SUPPLEMENT TO AMENDMENT TO OPERATING LICENSES NPF-4 AND NPF-7  
NORTH ANNA NUCLEAR POWER STATION UNIT NOS. 1 AND 2  
REACTOR COOLANT AVERAGE TEMPERATURE OF 587.8°F

ATTACHMENT 1

RESPONSE TO CONTAINMENT SYSTEMS BRANCH

AT RCS AVERAGE TEMPERATURE OF 587.8°F

Figure 15.4-21. Double Ended Cold Leg Break (Guillotine)

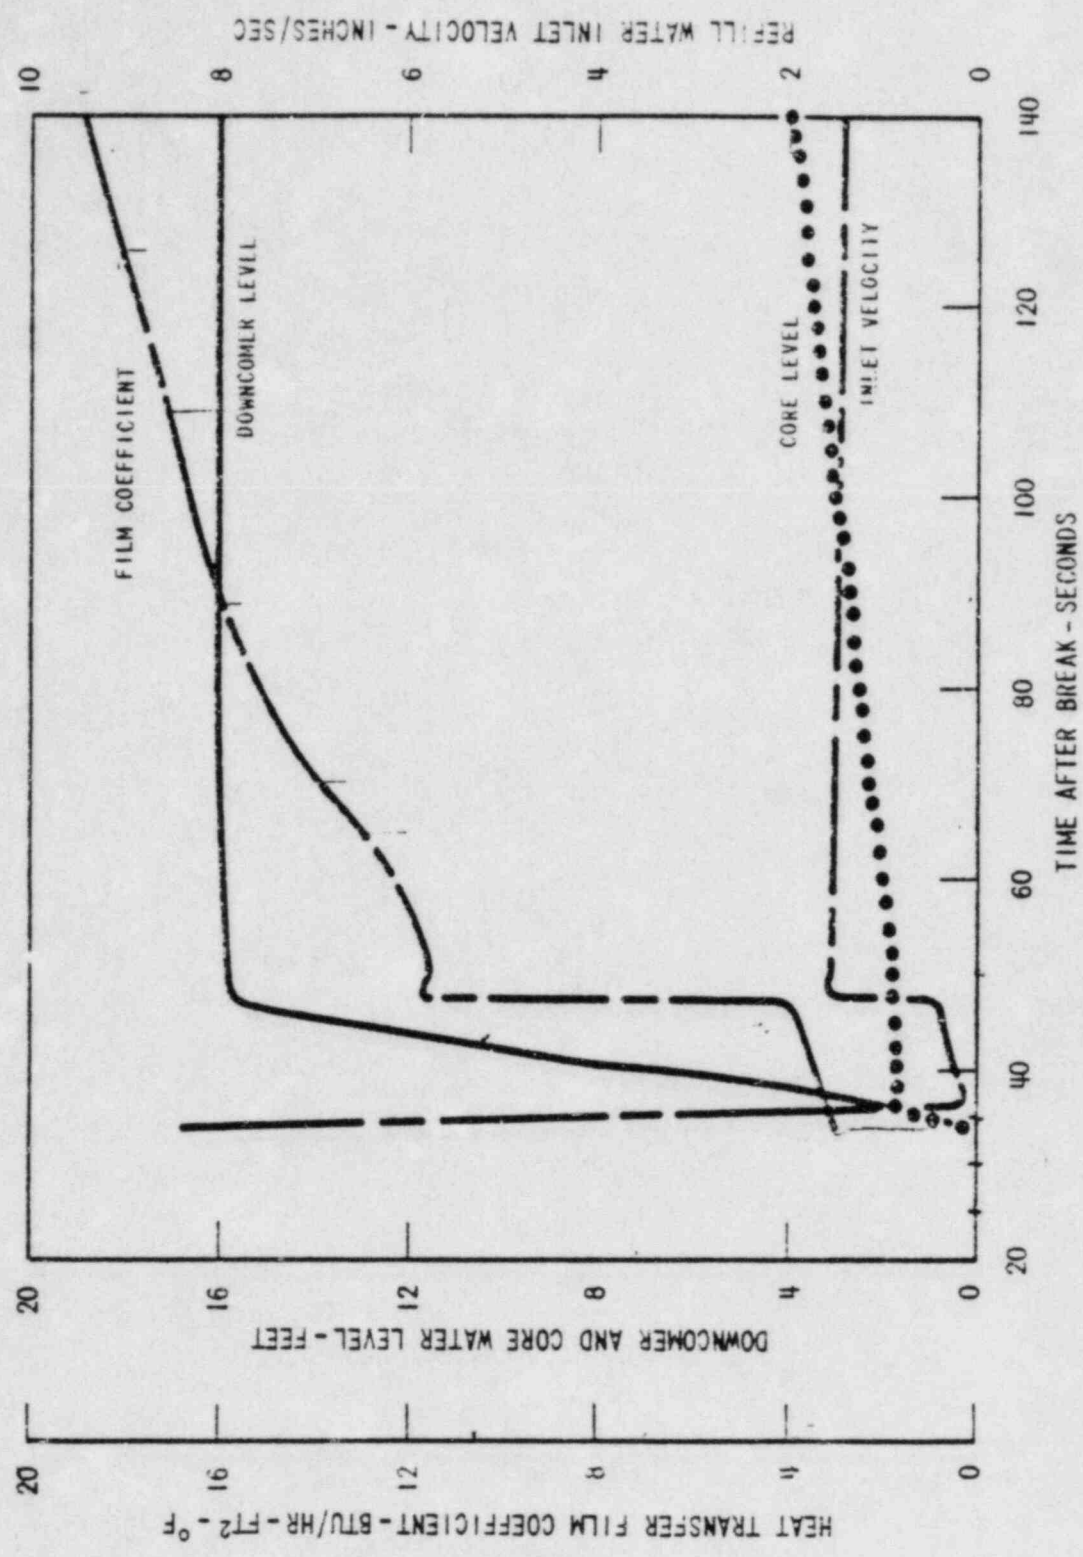
For the existing UFSAR calculations, a core reflood heat transfer coefficient of 1000 BTU/hr-ft<sup>2</sup>-°F was used in the analysis runs to calculate the 1st and 2nd containment peaks, and a RESAR 3 Curve (Reference attached Figure 2-1) was used in the analysis runs to calculate Depressurization Time and the 3rd containment peak. For the 7.5°F uprate, the value of 1000 was judged as overly conservative and a value of 3 times the RESAR-3 curve was used for 7.5°F uprate analysis runs.
